**LEXINGTON-FAYETTE URBAN COUNTY
GOVERNMENT CONTRACT CHANGE ORDER**
Page 1 of 2

Date: **June 16, 2015**
Project: Senior Citizen Center Construction
Location: Lexington
Contract No. 227-2014
Original Contract Amt. \$8,882,900.00
Cumulative Amount of Previous Change Orders \$228,161.07
Percent Change - Previous Change Orders 2.57%
Total Contract Amount Prior to this Change Order \$9,111,061.07
Change Order No. 18

Proposal for Remediation of Subgrade Conditions
at Paved Areas for Vehicle Traffic and Parking

PROJECT NAME:	LFUCG Senior Citizens' Center
PROJECT NUMBER:	201333
SUBJECT:	Parking Subgrade Remediation - Revised
DUE DATE:	6/25/2015
ID:	PR-018
SENDER ID:	
INITIATED BY:	Harding Dowell
REASONS:	Field Conditions
DISCIPLINE:	Civil Site
STATUS:	Closed
COP STATUS:	Not Received
CONTRACT:	Construction Services for Replacement Senior Citizens Center

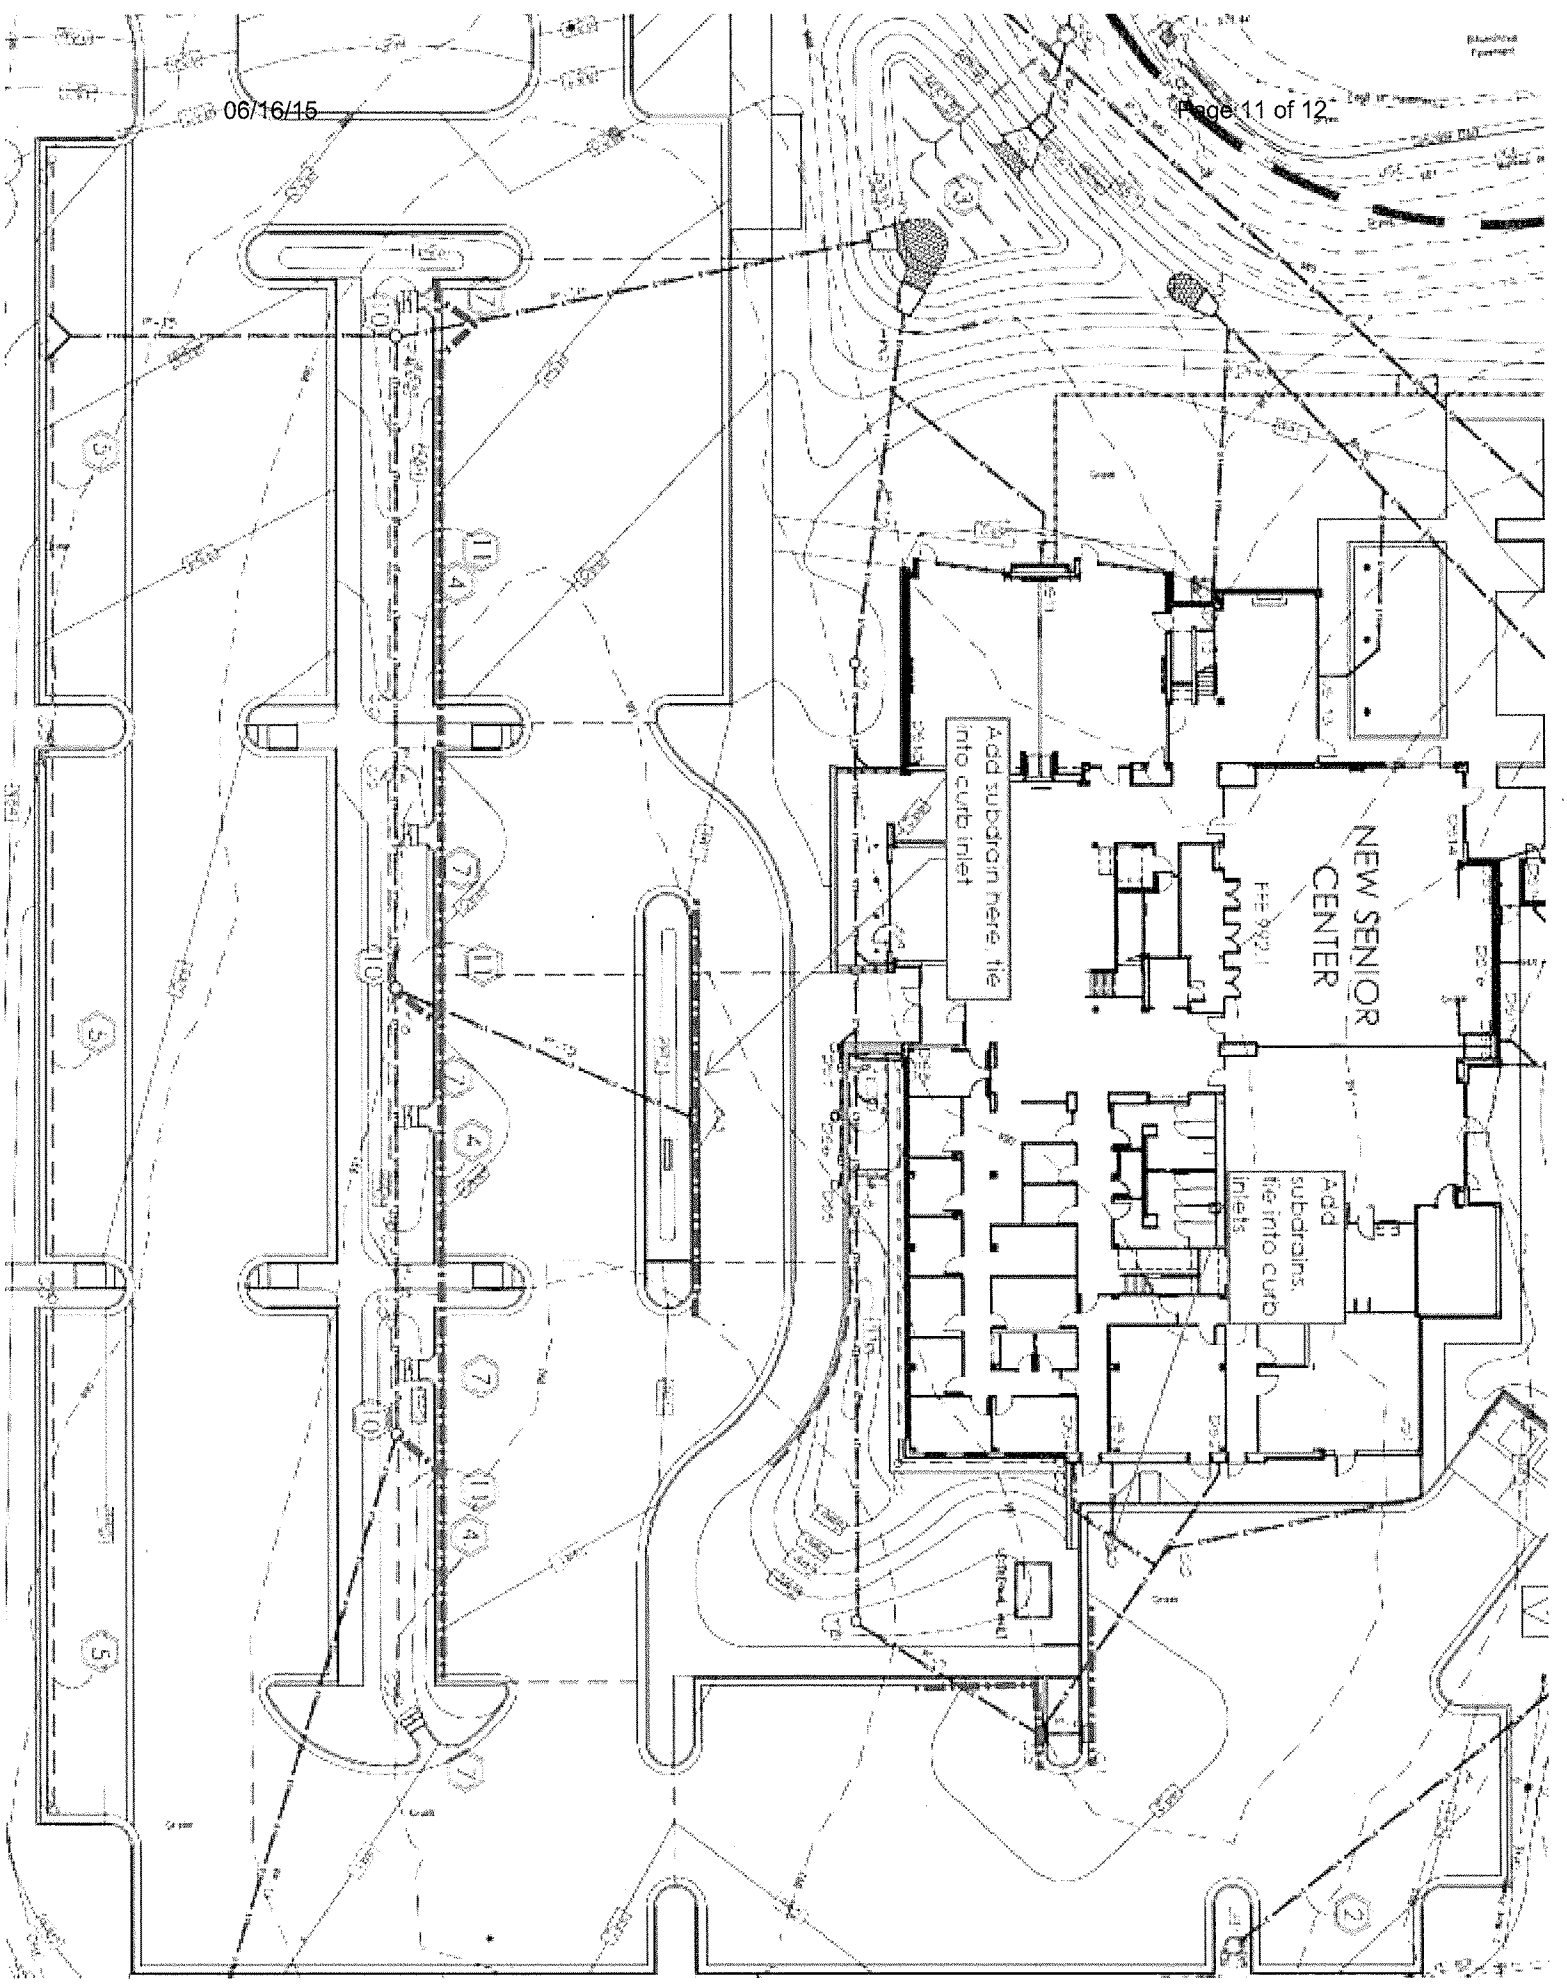
As promised, I was able to look into the possibility of replacing the base layer of Option 1 consisting of a layer of geogrid overlying a layer of filter fabric with a single layer of KYTC Type V High Strength Geotextile Fabric as mentioned by Martin Woodford with LFUCG during the site meeting last Wednesday.

- Line exposed undercut subgrade with a needle-punched non-woven geosynthetic filter fabric such as Propex 701 or Mirafi 170N. Provide lap of at least 12 inches to adjacent sides and ends.
- Overlie geosynthetic filter fabric with Tensar BX1300. Provide lap of at least 24 inches to adjacent sides and ends. Installation should be performed according to manufacturer and supplier recommendations

May be replaced with the following single application:

- Line exposed undercut subgrade with woven high performance geosynthetic fabric such as Mirafi HP570. Provide lap of at least 18 inches to adjacent sides and ends.

All other recommendations remain the same.
